OFFICIAL STAR CLASS MEASUREMENT CERTIFICATE

Report from International Measurement Committee

Star No. 3335

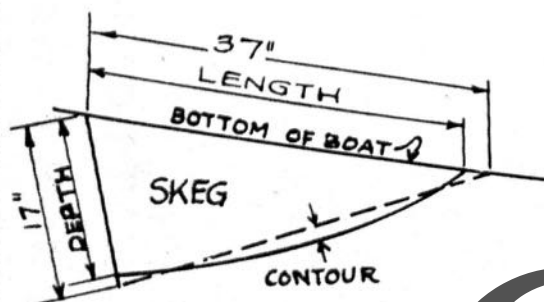
Side Height Station 8 - $18\frac{1}{4}"$
Maximum Allowed - $17\frac{27}{32}$

As per your instructions, the boat builder, Mr. Overfield, immediately corrected side height at Station 8 so that the dimension is now 1-5-64. This is less than the maximum allowed height (17 27/32") stated in your report on Star No. 3335.
